Houston Planning Commission

Platting Approval Conditions

Agenda Item: 33
Action Date: 03/16/2017
Plat Name: South Meadow Place Sec 1
Developer: SM Place FL-1, L.P.
Applicant: BGE, Inc.
App No/Type: 2017-0259 C3F

A SUBDIVISION OF 16.70 ACRES OF LAND
LOCATED IN THE
WILLIAM J. LOVETT SURVEY, A-526
CITY OF HOUSTON
HARRIS COUNTY, TEXAS

SHEET 1 OF 2

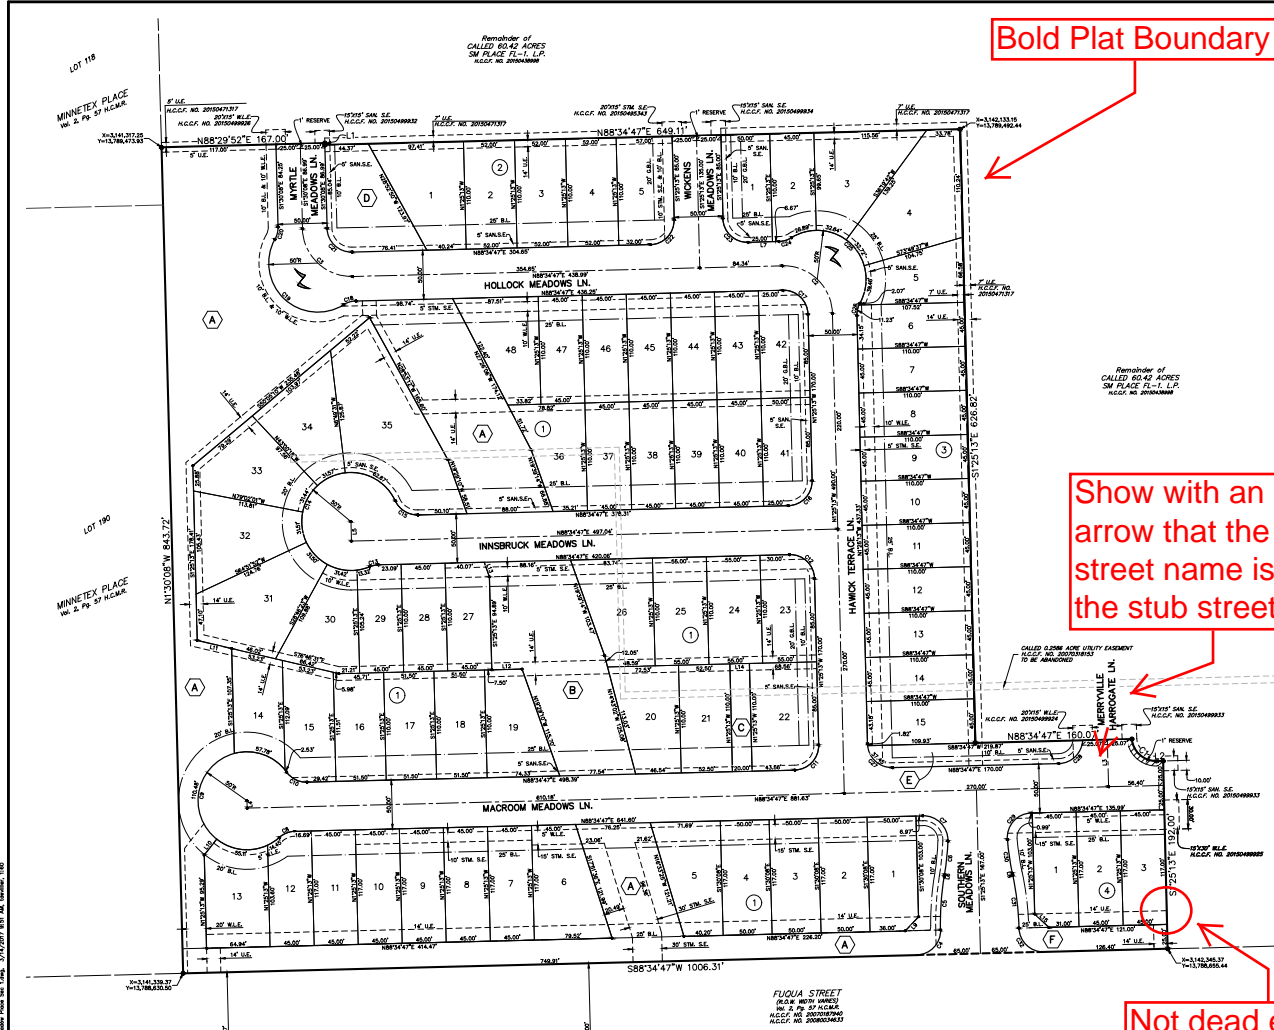
Show with an arrow that the street name is for the stub street

Not dead end UEs
It need to connect
with the street

waste water note

all easements
must match title
report at
recording
